**SECTION 16 APPLICATION
TOWN PLANNING ORDINANCE (CHAPTER 131)**

**PROPOSED SOCIAL WELFARE FACILITY (RESIDENTIAL CARE HOME FOR PERSONS WITH
DISABILITIES) IN “VILLAGE TYPE DEVELOPMENT” ZONE ON APPROVED NAM SANG WAI
OUTLINE ZONING PLAN NO. S/YL-NSW/10 AT LOTS 3669 S.A RP (PART), 3669 S.B RP (PART),
3670 RP (PART) AND ADJOINING GOVERNMENT LAND IN D.D.104, NAM SANG WAI, YUEN LONG**

Town Planning Application No. A/YL-NSW/348 - Submission of Further Information (6)

**(Planning Application No. A/YL-NSW/348)
Response-to-Comment Table**

Figure Title
THE WALKING PATH BETWEEN THE PROPOSED RCHD AND THE NEARBY FRANCHISED BUS STOPS

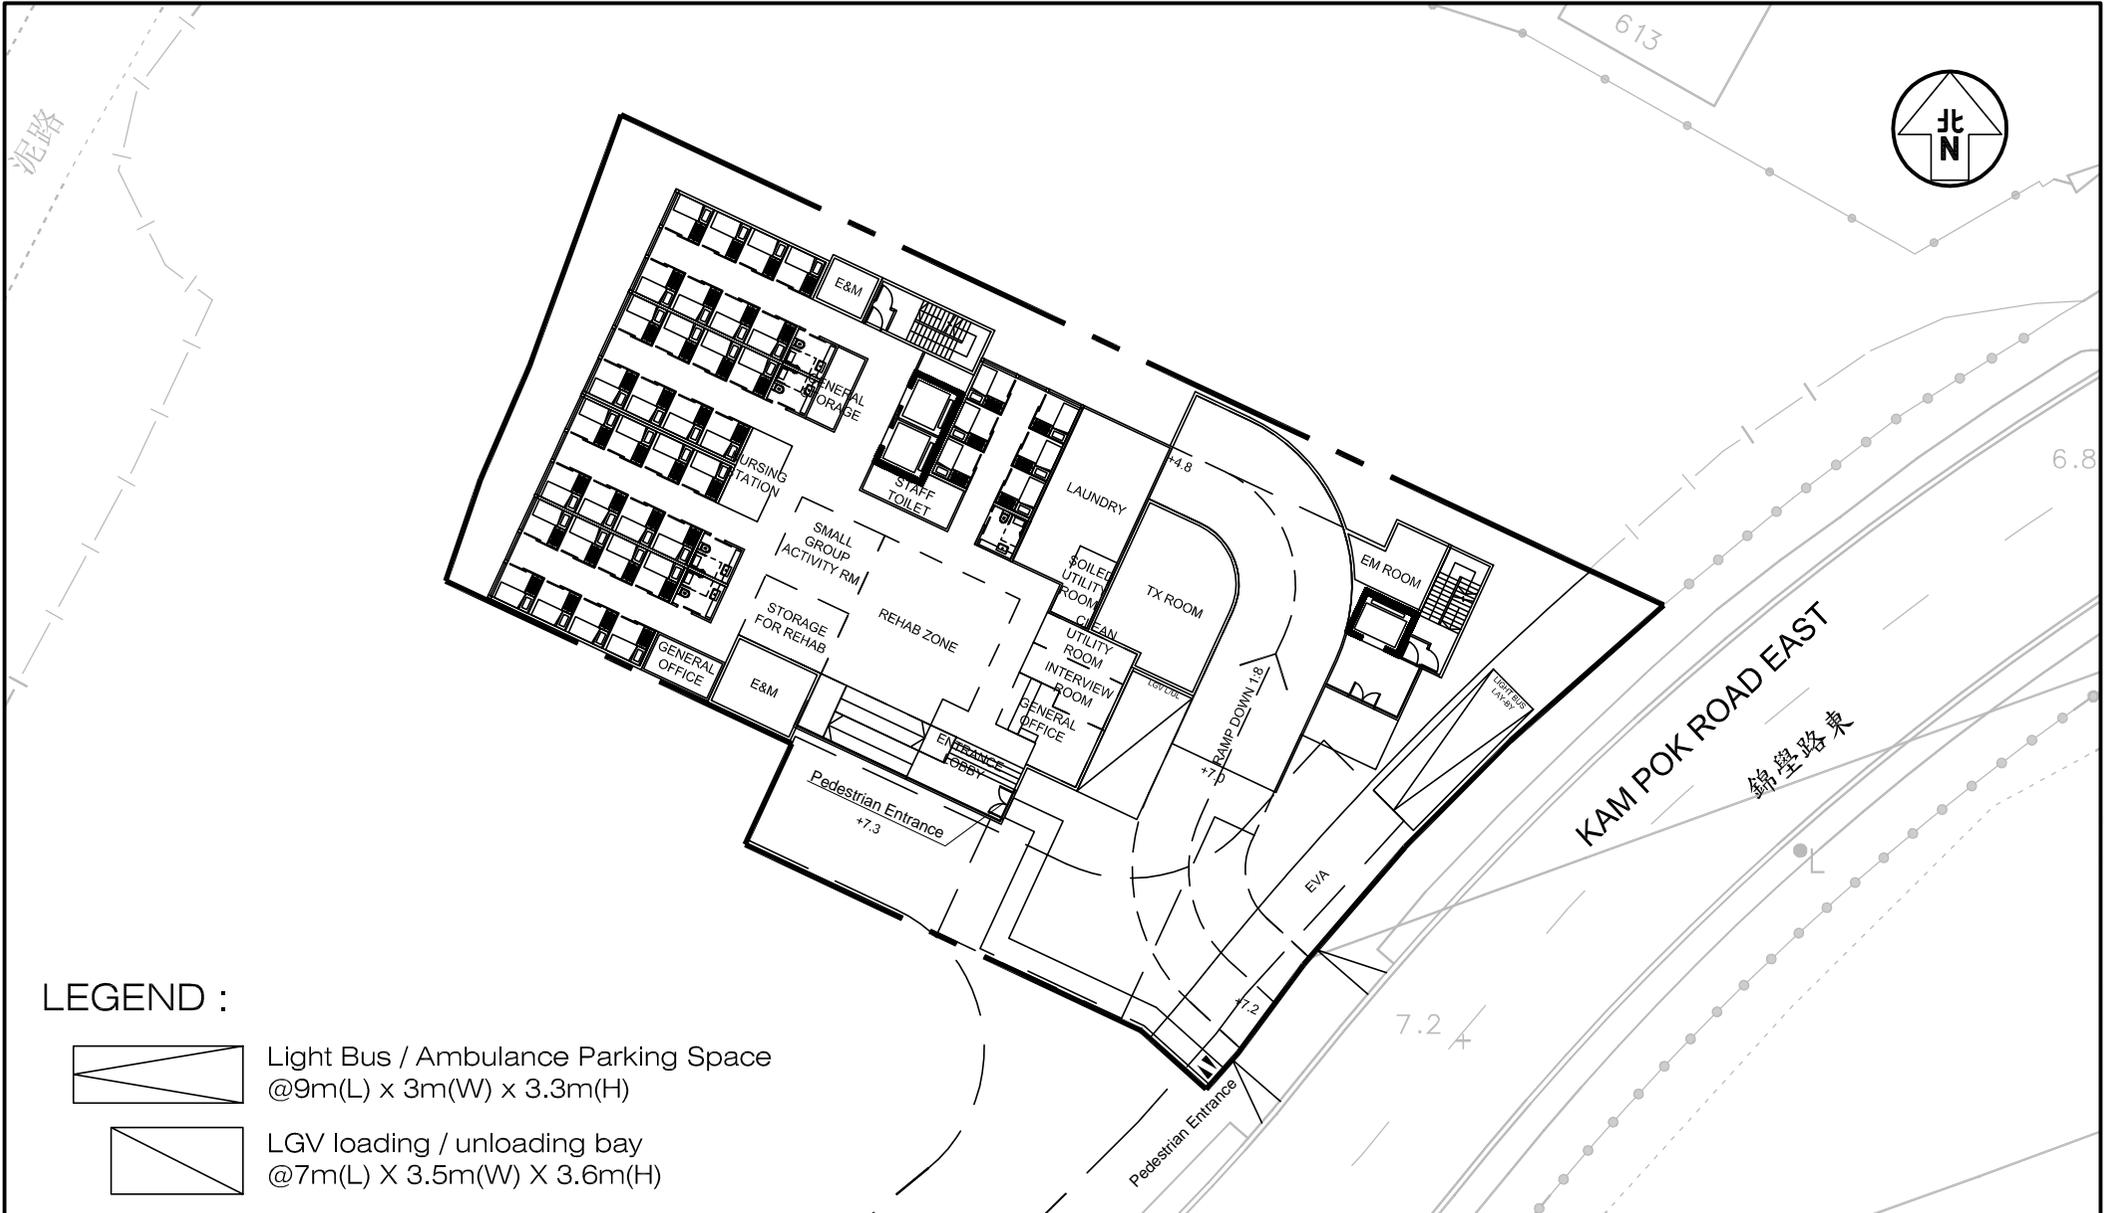
12. Please provide a plan showing the pedestrian routing to the nearby franchised bus stop (both Yuen Long and Sheung Shui bound). Please specify the corresponding walking distance as well;	Noted. Please refer to Figure 2.7 in the revised TIA for the pedestrian route to the nearby franchised bus stops.

Figure Title **LENGTH OF VISIBILITY LINE FOR THE MOTORIST LEAVING THE PROPOSED RCHD AT KAM POK ROAD EAST**

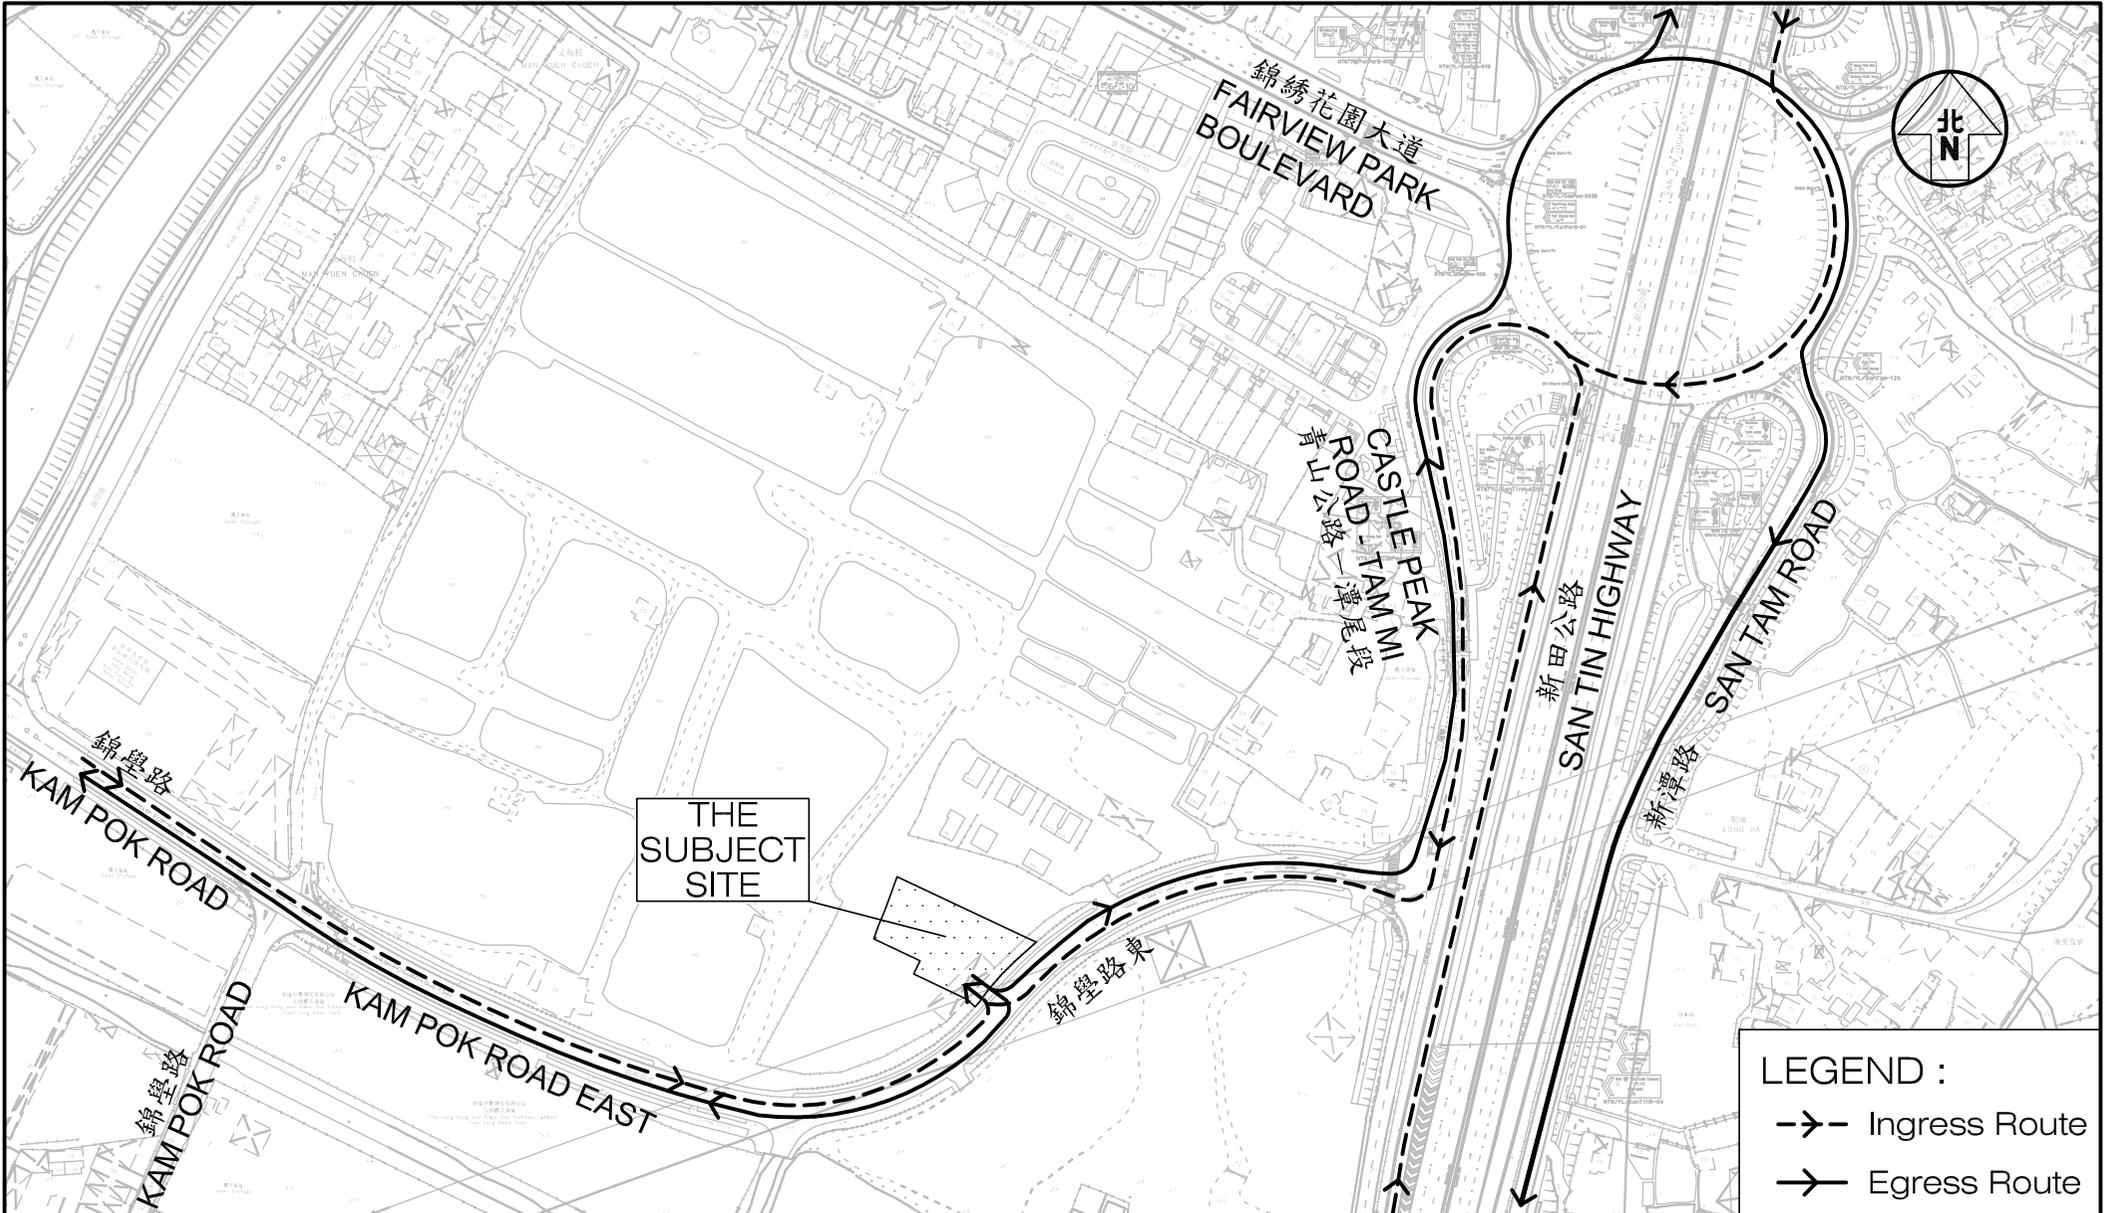
2.	Given the congested area at the site entrance, the management staff should be on-site at all time to manage the traffic.	Noted.
3.	Re. RtC Item 6: It appears that your checking of visibility splay has not taken into account of the existing planter. Please revisit the checking and demonstrate sufficient sightline could be maintained at all time since the commissioning of RCHE.	In order to ensure the adequate sightline for vehicles and pedestrian, the amendment of existing planter is needed to ensure no obstructions taller than 1.05m will be erected within the visibility splay at the run-in/out.

- 3.4 The carpark layout plans for G/F and B/F are shown in Figures 3.1 – 3.2.
- 3.5 The measured length of visibility splay for the motorists leaving the Proposed RCHD is 60m to the left and 60m to the right, which is illustrated in Figure 3.3.

Modification Plans of Noise Barrier and Street Furniture

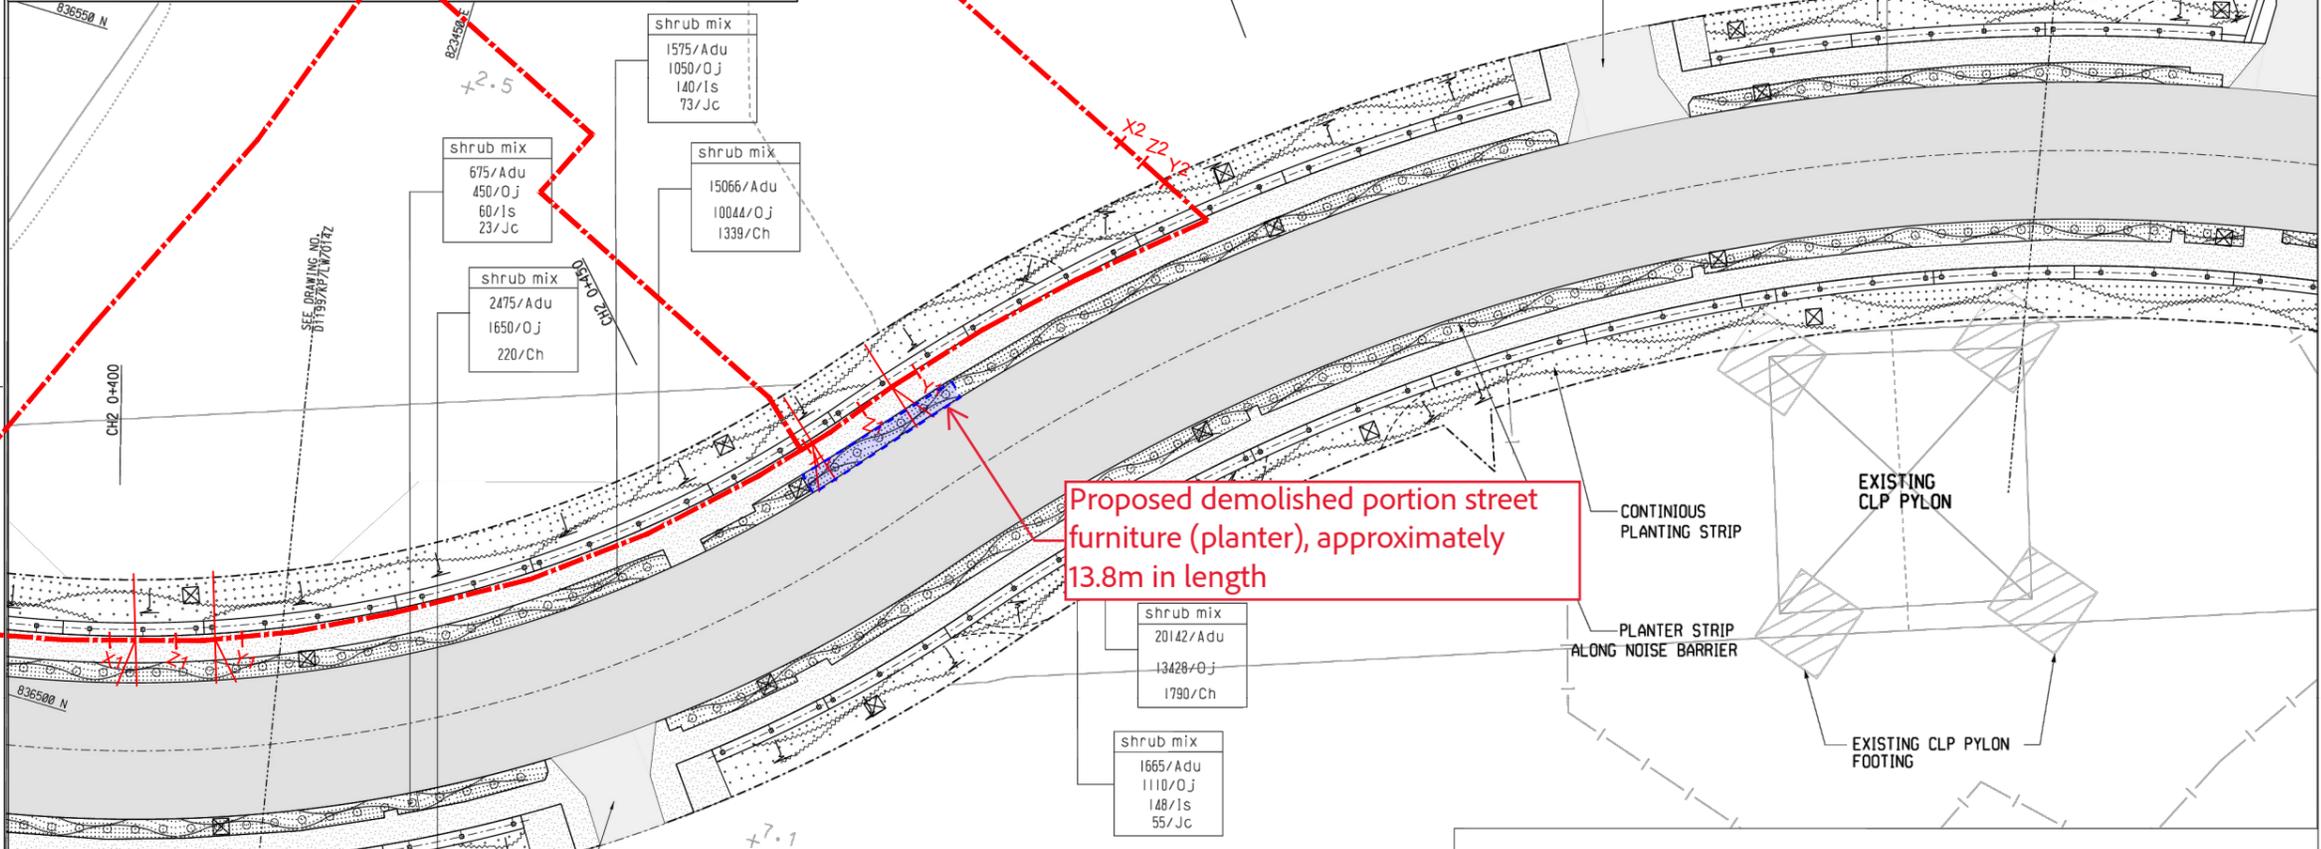
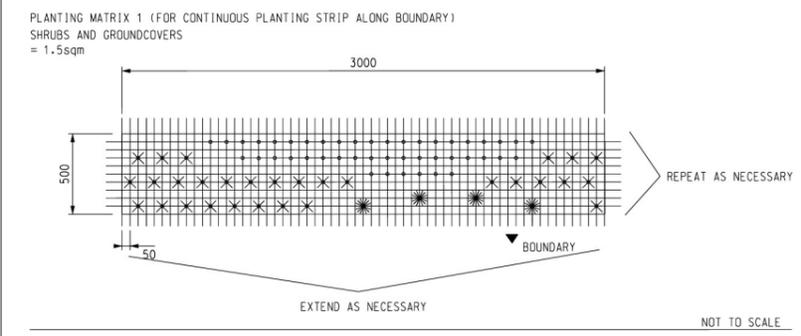
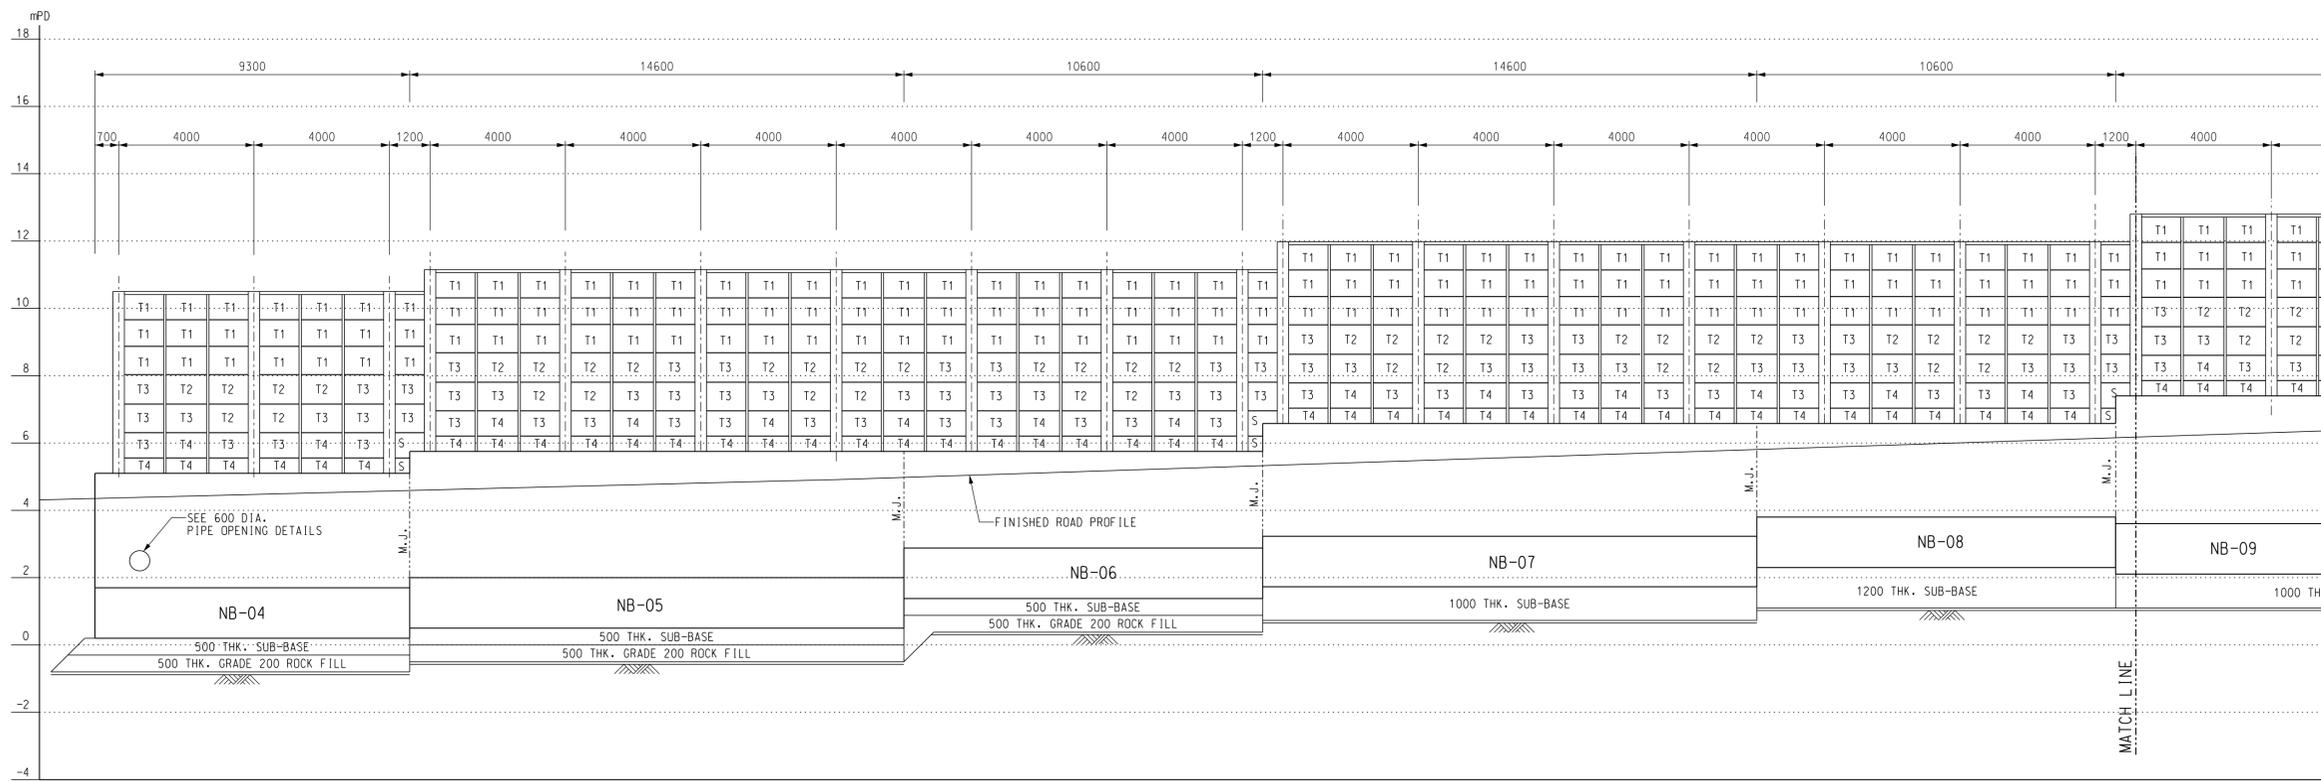
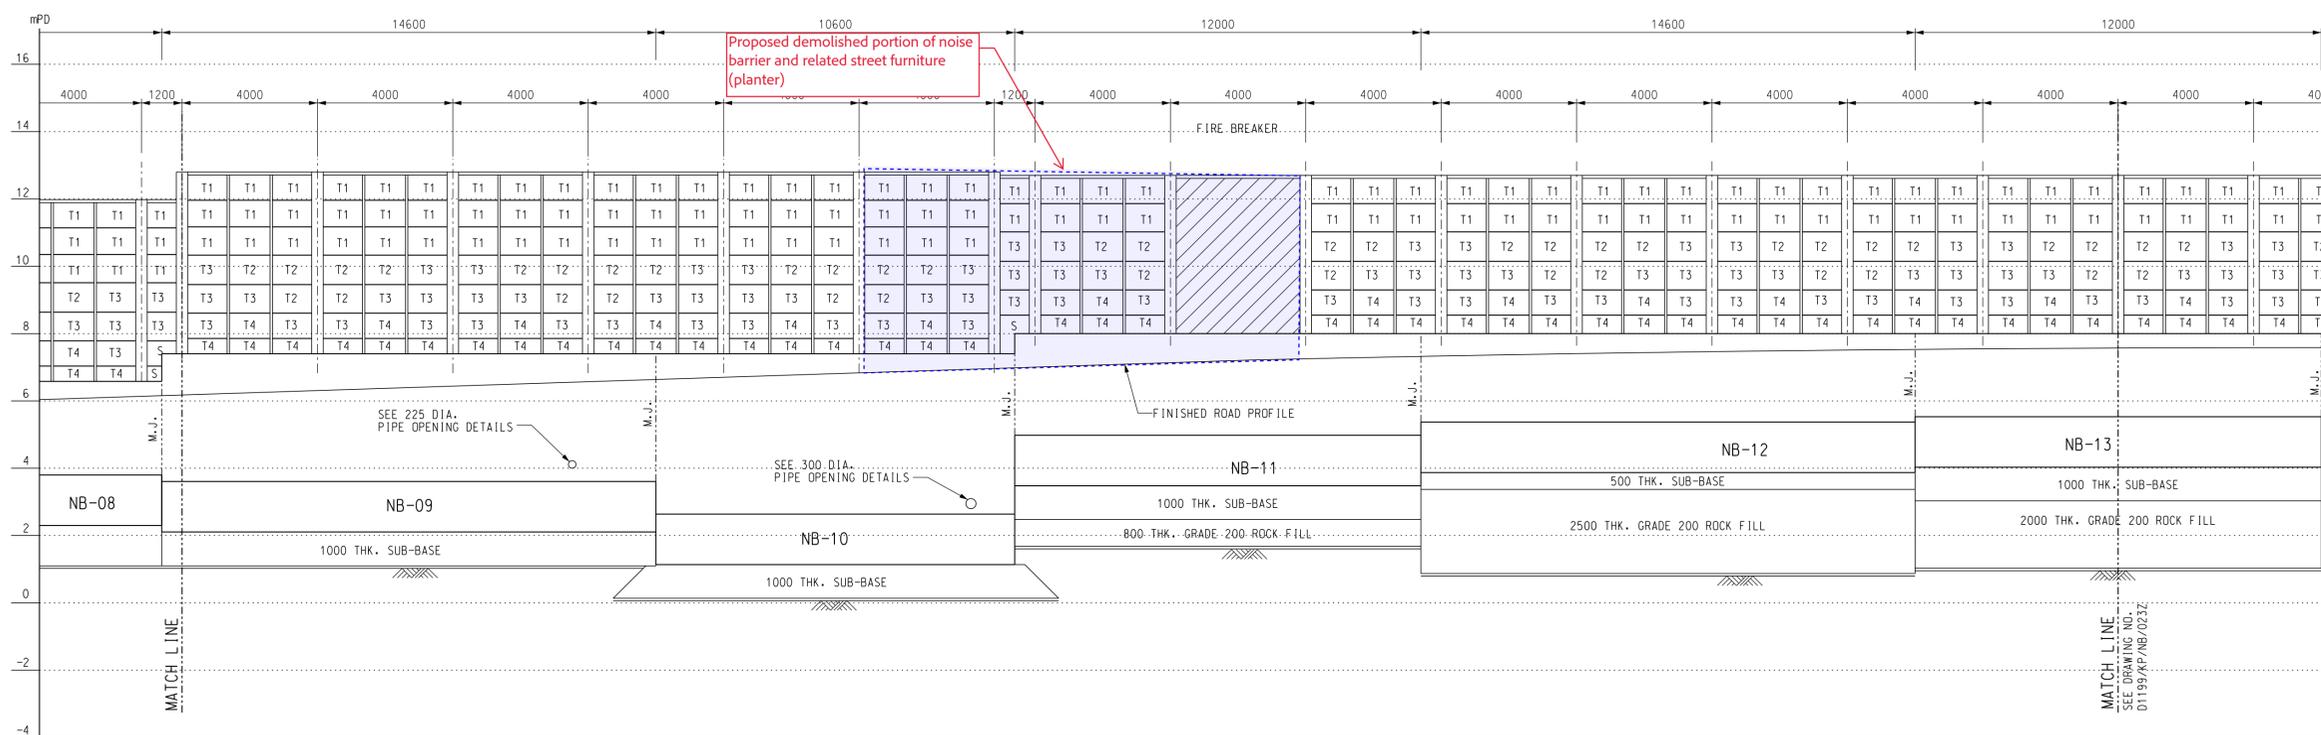
1.	Noise Please supplement in the report the reason(s) for the proposed demolition of the existing noise barrier.	See revised Environmental Assessment (Appendix 2). The discussion is provided in Section 3.4.7.

Proposed demolished portion street furniture (planter), approximately 13.8m in length
